## Recommended Amendments to the 2024 International Fire Code

North Central Texas Council of Governments Region

**FIGURE D103.6  
FIRE LANE SIGNS**

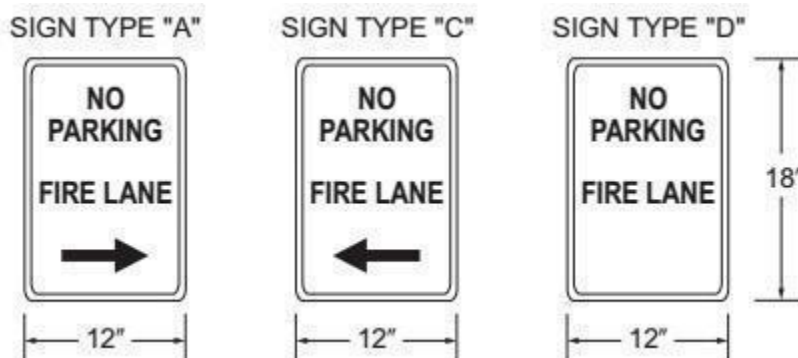
**D103.6 Signs. Marking.** Striping, signs, or other markings, when approved by the *fire code official*, shall be provided for fire apparatus access roads to identify such roads or prohibit the obstruction thereof. Striping, signs and other markings shall be maintained in a clean and legible condition at all times and be replaced or repaired when necessary to provide adequate visibility.

**(1) Striping** – Fire apparatus access roads shall be continuously marked by painted lines of red traffic paint six inches (6”) in width to show the boundaries of the lane. The words “NO PARKING FIRE LANE” or “FIRE LANE NO PARKING” shall appear in four inch (4”) white letters at 25 feet intervals on the red border markings along both sides of the fire lanes. Where a curb is available, the striping shall be on the vertical face of the curb.

**(2) Signs** – Signs shall read “NO PARKING FIRE LANE” or “FIRE LANE NO PARKING” and shall be 12” wide and 18” high (See Figure D103.6). Signs shall have red letters on a white reflective background, using not less than 2” lettering. Signs shall be permanently affixed to a stationary post and the bottom of the sign shall be six feet, six inches (6’6”) above finished grade. Signs shall be spaced not more than fifty feet (50’) apart along both sides of the fire lane. Signs may be installed on permanent buildings or walls or as approved by the Fire Chief.

~~Where required by the fire code official, fire apparatus access roads shall be marked with permanent “NO PARKING FIRE LANE” signs complying with Figure D103.6, or other approved method. Signs shall have a minimum dimension of 12 inches (305 mm) wide by 18 inches (457 mm) high and have red letters on a white reflective background. Signs shall be posted on one or both sides of the fire apparatus road as required by Section D103.6.1 or D103.6.2.~~

*(Reason: Reflects current markings for apparatus access roadways as indicated in the recommended amendment to Section 503.3)*
